# TECHNICAL SERVICE INFORMATION BULLETIN

TSIB 24-05 Rev A		July 30, 2024
<b>TO:</b>	All Operators	
<b>TITLE:</b>	L9 Alternator Belt Layout Modification	
<b>APPLICABILITY:</b>	Applies to all MCI J3500 coaches

Belt Shredding and Change in Belt Layout: MCI

Figure 1, New Parts Kit, Part Number 5335096.

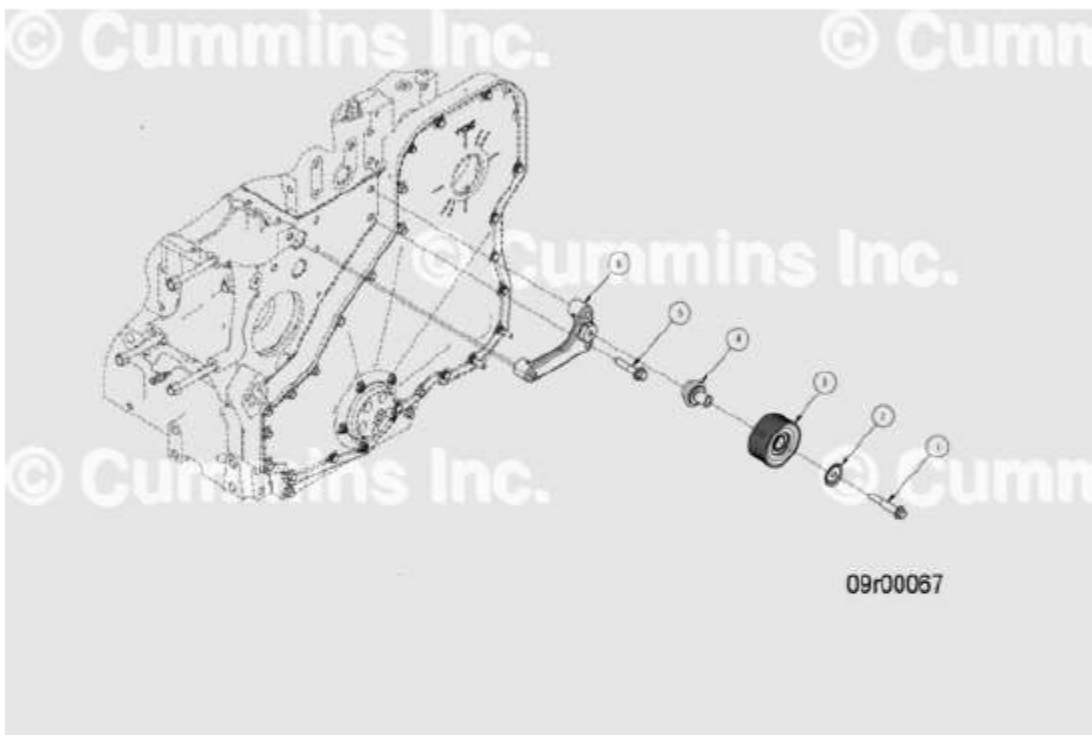
- Use kit, Part Number 5335096, to relocate pulley, Part Number 4991240.
- Replace belt, Part Number 3289558, with new belt, Part Number 5690240.
- For CM2450 2021 build year and up, relocate wiring harness clip, Part Number 68152, from location 1 to 2 in Figure 2.

Figure 1 Number	Part Number	Name	Quantity	Instructions
1	5364663	SUPPORT, IDLER PULLEY	1	New mounting bracket
2	3093826	SCREW, HEXAGON FLANGE HEAD CAP	2	Torque to 65 N•m [ 50 ft-lb ]
3	3935229	SHAFT, IDLER	1	Replace as needed.
4	4991240	PULLEY, IDLER	1	Use original ribbed pulley.

Figure 1 Number	Part Number	Name	Quantity	Instructions
5	4945913	SHIELD, DUST	1	Discard. Reuse dust shield, Part Number 3921533
6	3900635	SCREW, HEXAGON FLANGE HEAD CAP	1	Torque to 65 N·m [ 50 ft-lb ]
Not Shown	3910901	SCREW, HEXAGON FLANGE HEAD CAP	1	Discard
Not Shown	3970945	PULLEY, IDLER	1	Discard

Picture of the new layout:

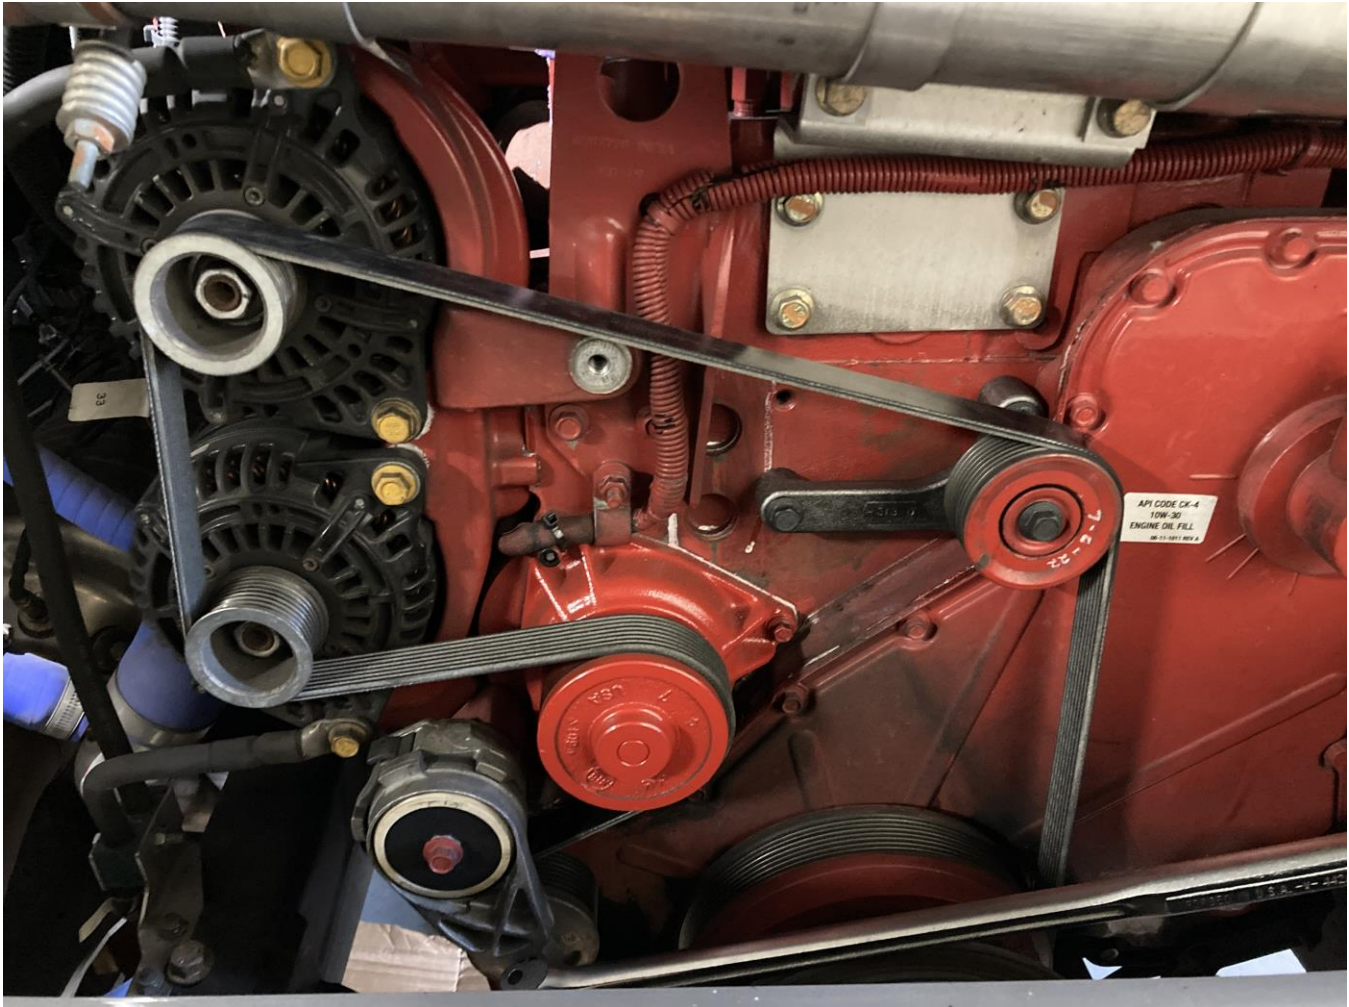
- If the belt is broken or shredded, the new idler location and new belt layout change are recommended.
- Discard the new dust shield and ribbed pulley from the kit. Reuse the existing dust shield and original ribbed pulley.
